Planning and Zoning Commission

February 5, 2020 – REGULAR MEETING

TOWN OF JACKSON PLANNING COMMISSION AGENDA DOCUMENTATION

SUBJECT: **ITEM P19-262:** AMENDMENT TO THE FINAL (MAJOR) DEVELOPMENT PLAN FOR PINE GLADES PLANNED UNIT DEVELOPMENT (PUD).

Proposed 2019 Changes to Duplex:

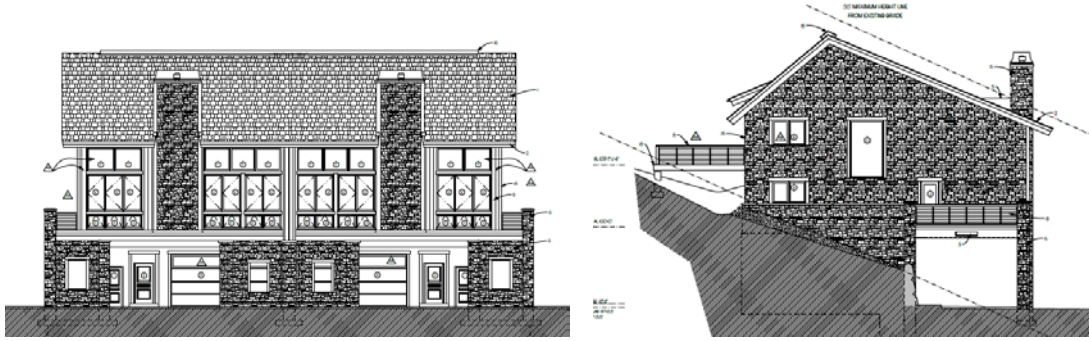
An amendment to the Pine Glades Development Plan was approved in 2017 (P17-045) which included architectural changes to roof pitches and exterior materials for all three duplexes within Phases I & II. The applicant is now seeking to make several small changes to only the duplex at 140 & 142 Pine Glades Drive which include the use of stone as the main exterior material on the side elevations (east and west). The stone proposed on the side elevations would go from the base of the unit to the roof. Previous designs had stone about half way up the building which transitioned into horizontal wood siding and wood shingles. In addition, the stone chimney on the front (north) elevation would no longer continue to the ground, but would start on the second story. Windows on all elevations would be changed slightly with regard to size and location. Additional stone is also proposed on the ground level columns and the columns themselves would be widened.

Staff has no significant concerns with the proposed exterior changes. The additional stone is viewed as an upgrade and requires less maintenance than wood. In addition, the use of stone is common throughout the development and the applicant is not introducing a new material. No additional height or floor area is proposed. Staff has added a condition of approval requiring the applicant to submit an addendum to the duplex building permits to reflect the materials proposed in this application.

1. Prior to issuance of Certificate of Occupancy on the duplex at 140 & 142 Pine Glades Drive, the applicant shall apply for an addendum to the duplex building permits to revise all exterior elevations to reflect the approved materials and changes.

Currently Approved Trails (red = removed, blue = approved/installed, black = installed/Phase II):

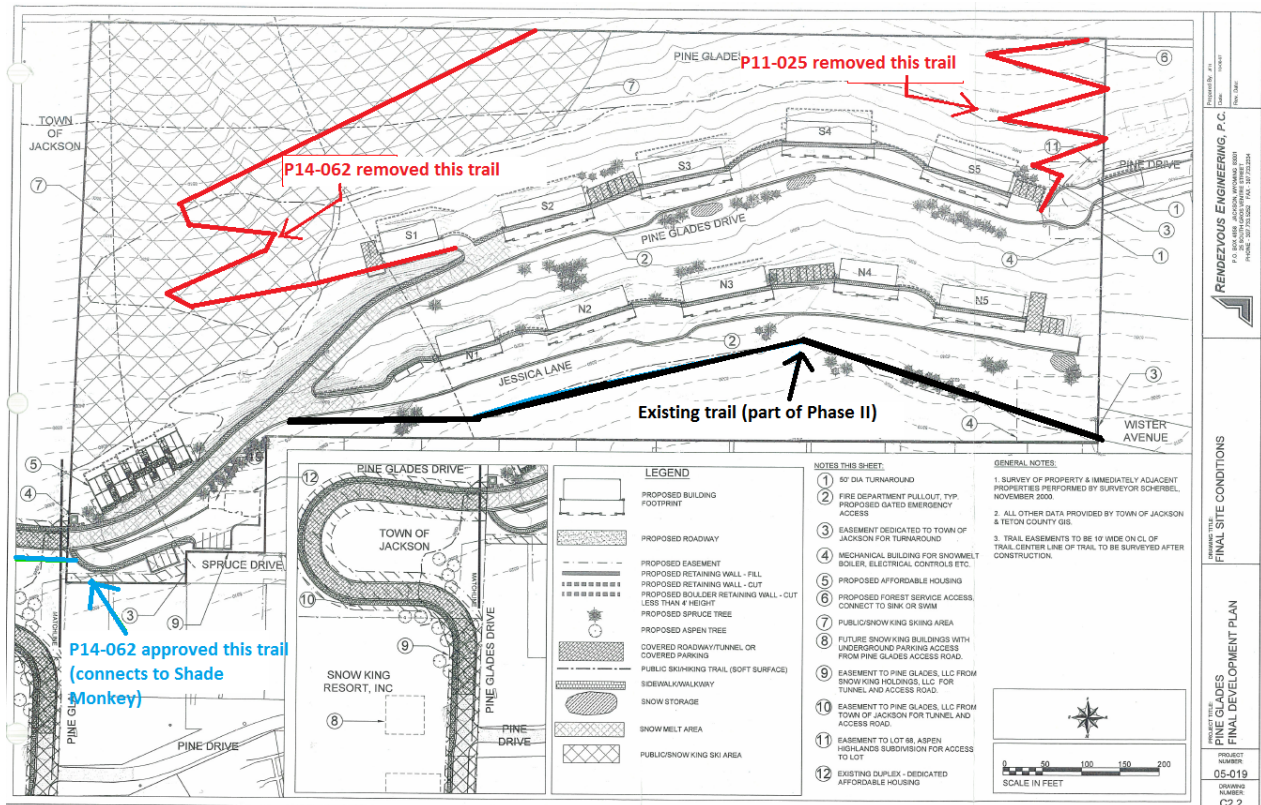
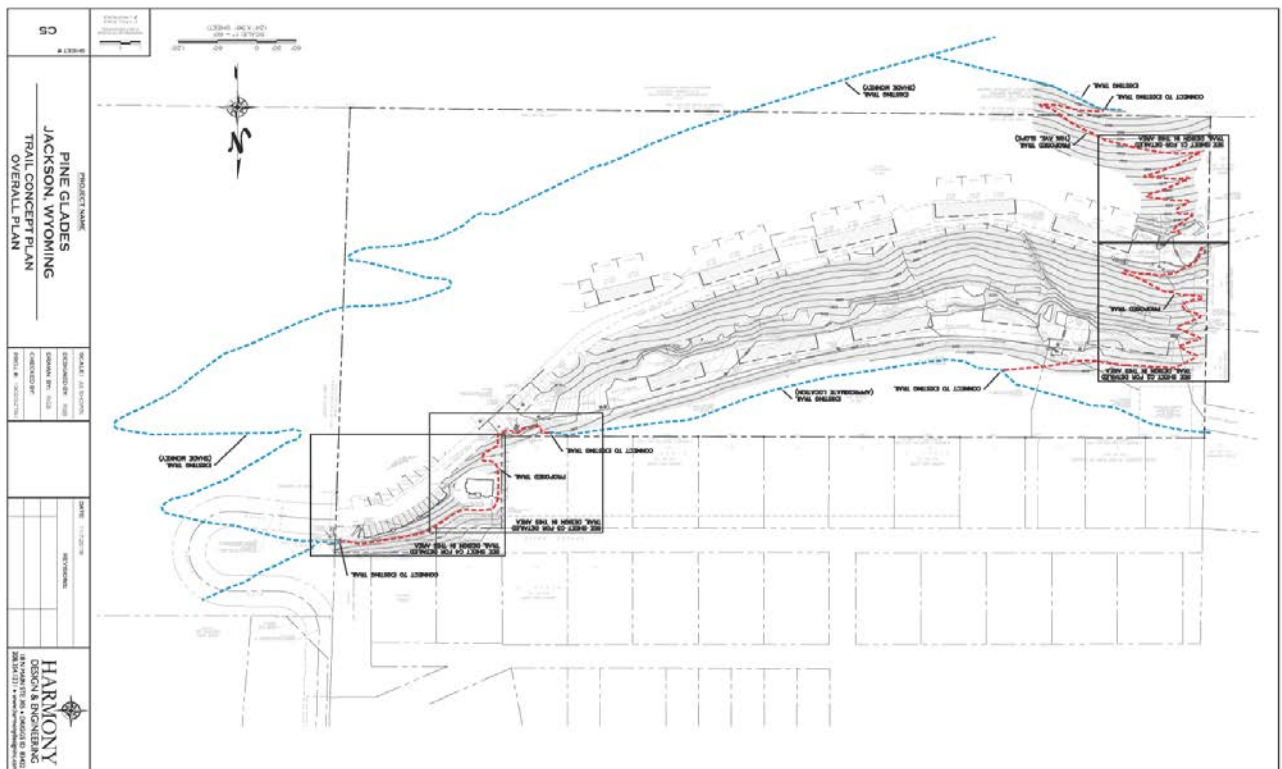
The original trail plan was changed twice in 2011 and 2014 through staff level reviews. In 2011 a Minor Deviation (P11-025) was approved to relocate the west trail that switchbacks up the hill from the cul-de-sac (connecting to the Sink or Swim trail) to the center of the site next to the duplex at 140 & 142 Pine Glades Drive. This relocation request was made due to stated concerns over the steepness of the slope in the original west location. This new section of trail near the duplex was installed and connected to Sink or Swim. Accessing the trail at this location required neighbors on Pine Drive to walk approximately 900 feet on Pines Glades Drive and the trail was used for a couple of years until the trail was relocated again at the request of the developer.

In terms of the proposed trail plan itself, staff finds that, while it may provide fewer lineal feet of total trails, it will provide a similar level of connectivity to adjacent trails as the original trail network. The one significant caveat is that no public access is proposed for the private internal roads, except for the cul-de-sac to access the two western switchback trails. While some portions of the trail are on steep slopes, the proposed design is suitable for the conditions and comparable to other trails. For example, the proposed trail section leading up from the cul-de-sac was included in the original approval and maintains an average 10% slope. Although stone steps will be incorporated throughout the trail plan making it difficult for bicyclists, it will still serve as a multi-use summer trail system. Although not discussed in much, if any, detail in the original approval, the applicant is not proposing and is not required to maintain the trails for winter use. This makes sense given that the Sink or Swim trail is not maintained by the USFS in the winter so there is little reason to require a higher level of maintenance on the private trails that connect to Sink or Swim. Nevertheless, as with the USFS trails, it is staff's understanding that the Pine Glades trails can be used by trail users in the winter at their own option but they will not be maintained.

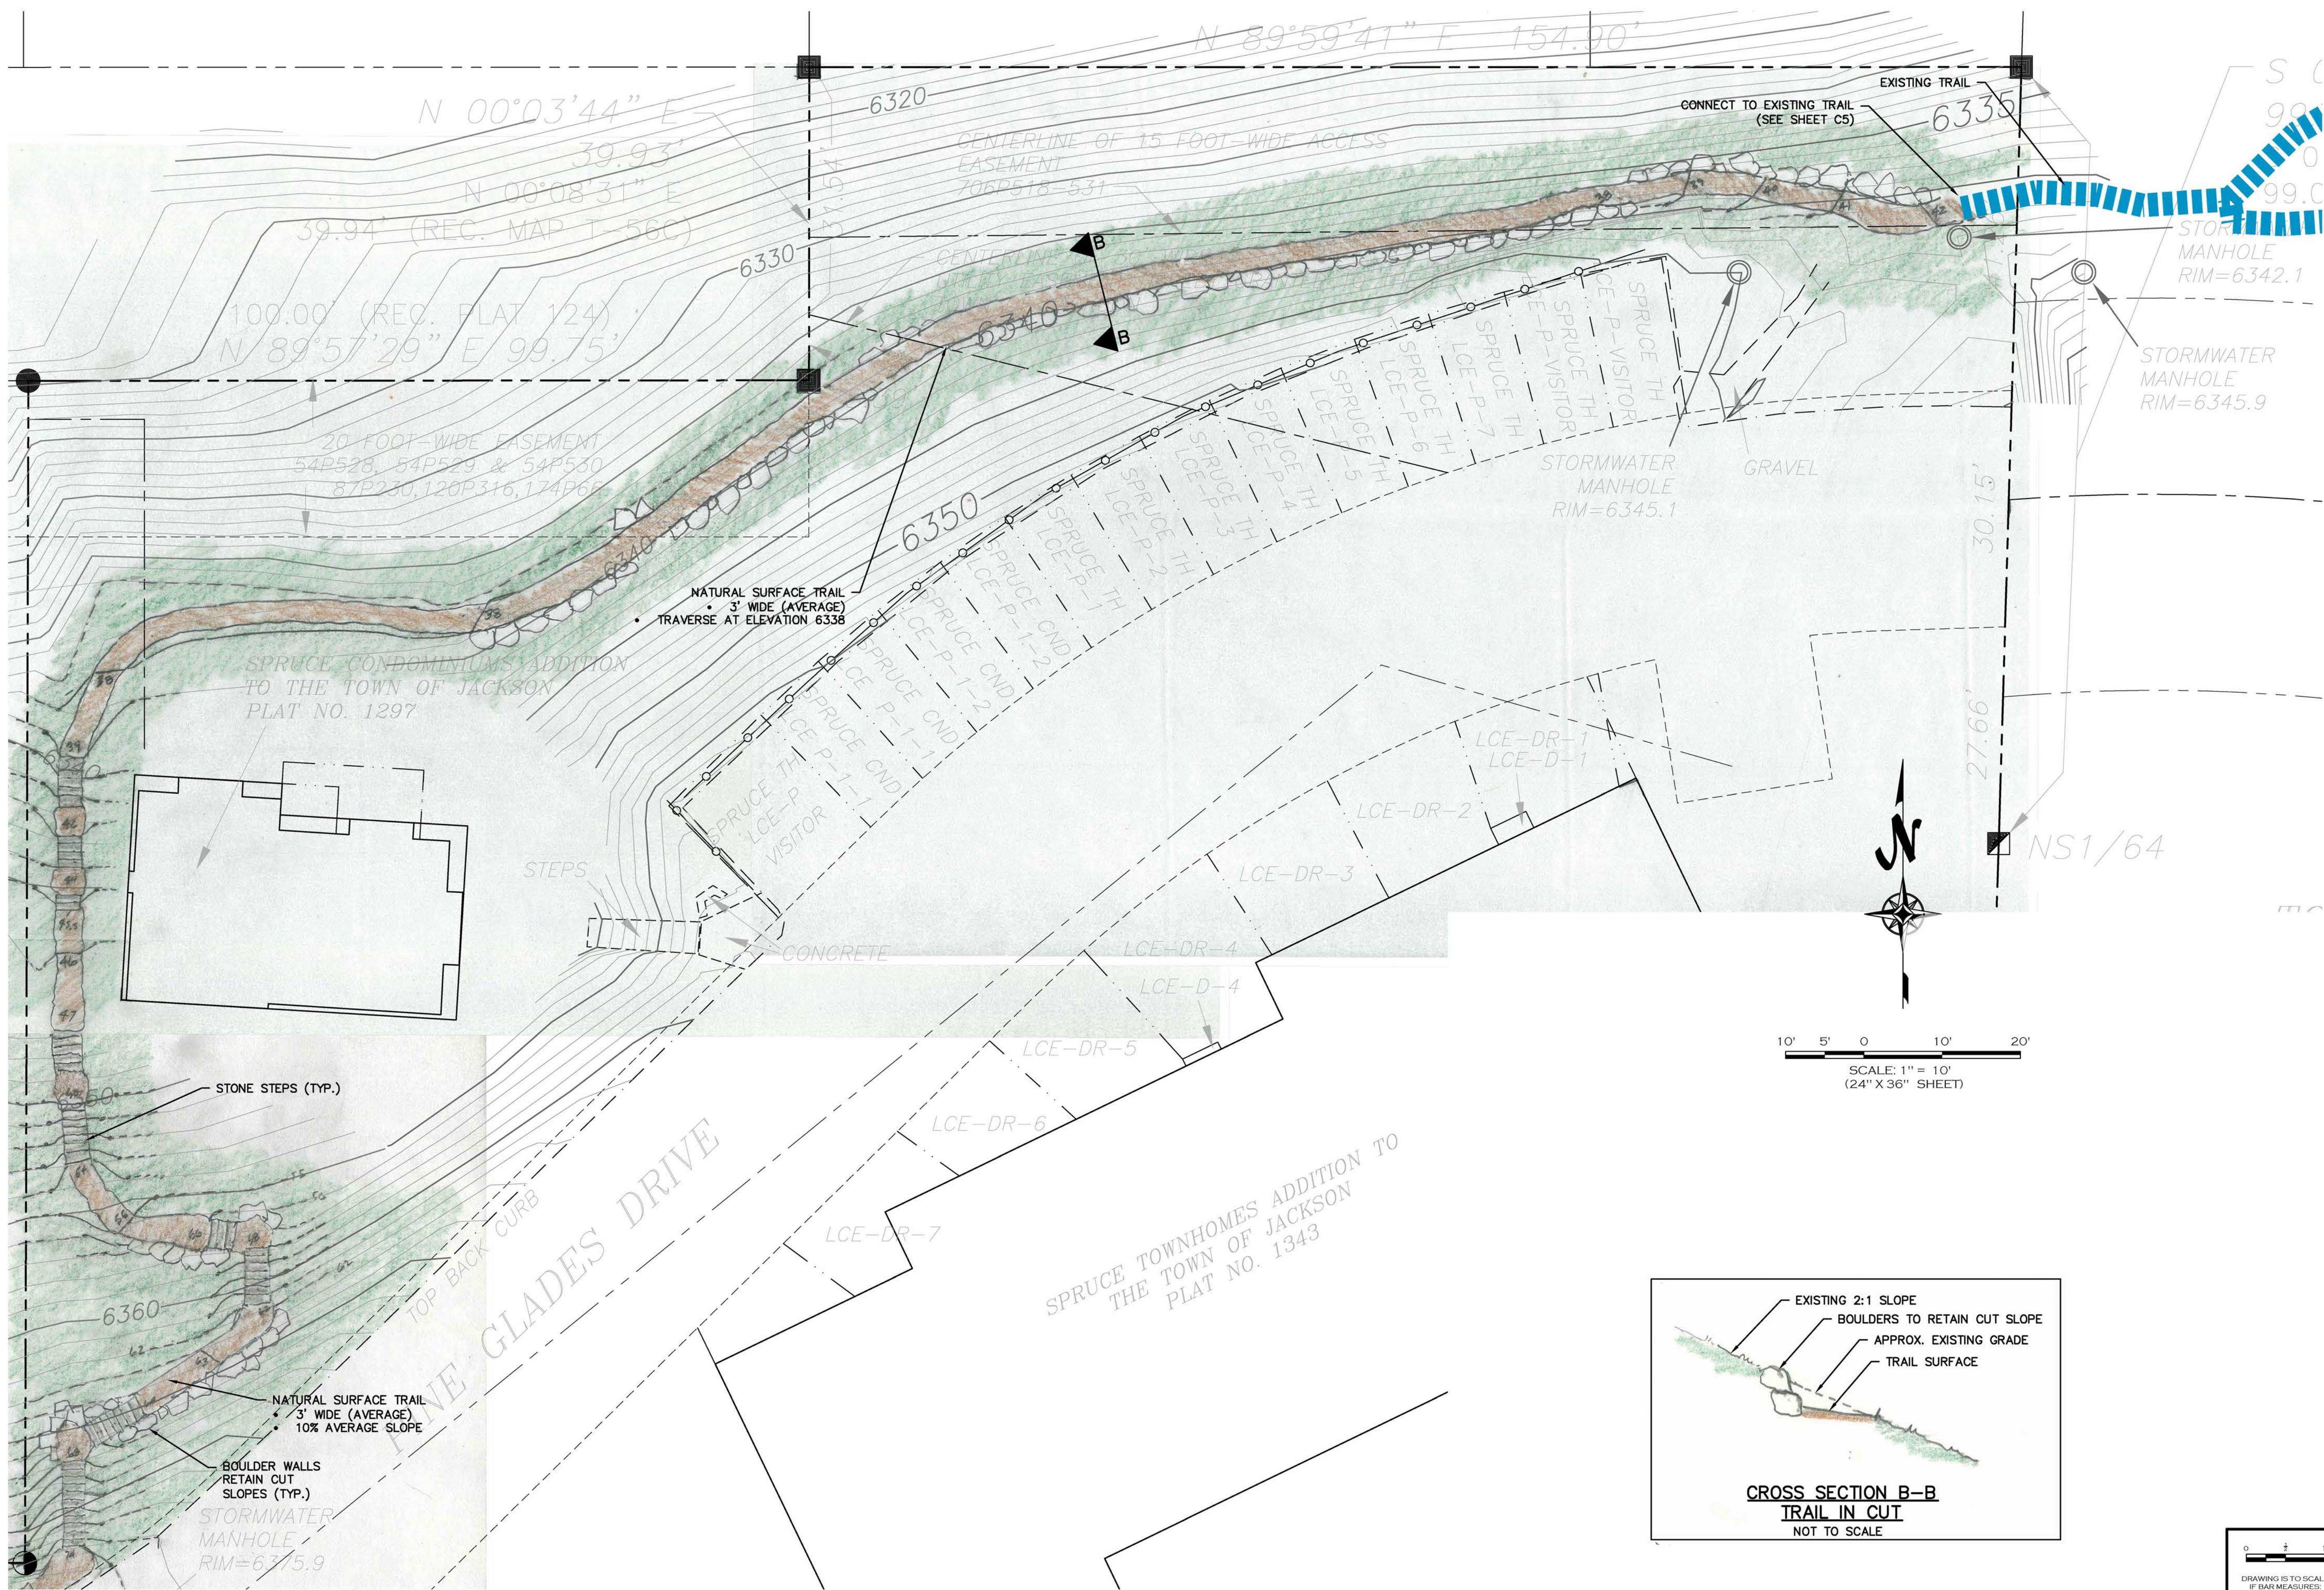
- The first new section of trail (below in red) starts at the cul-de-sac on Pine Glades Drive and switchbacks up the hill (south) and connects to Sink or Swim which is located on the USFS property. The total elevation from the cul-de-sac to the Sink or Swim connection is approximately 90 feet over a total horizontal distance of approximately 375 feet.

While the revised trail provides essentially the same connectivity (start and end points) and I feel it meets the intent of the trail connection, it's not as nice a trail route for the users as it will be butt up against a retaining wall for much of the route and a 5' attached sidewalk for the rest, neither of which is a great trail design. The new route is a little more direct and has fewer stairs (although essentially the same overall vertical drop and gain), but overall the original route was a better design. So, I feel it's acceptable but a step down from the originally proposed route.

3. Prior to September 1, 2020, the applicant shall work with the Fire Department and Planning Department on an appropriate landscape screening plan for the first section of trail above the cul-de-sac that does not conflict with the Wildland Urban Interface code requirements.

5. The applicant shall make all efforts to not disturb mature Spruce trees in the section of the trail below the cul-de-sac. Any necessary removal of trees will require new trees to be planted to ensure adequate screening is maintained. All new trees will require approval from the Fire Department and Planning Department.
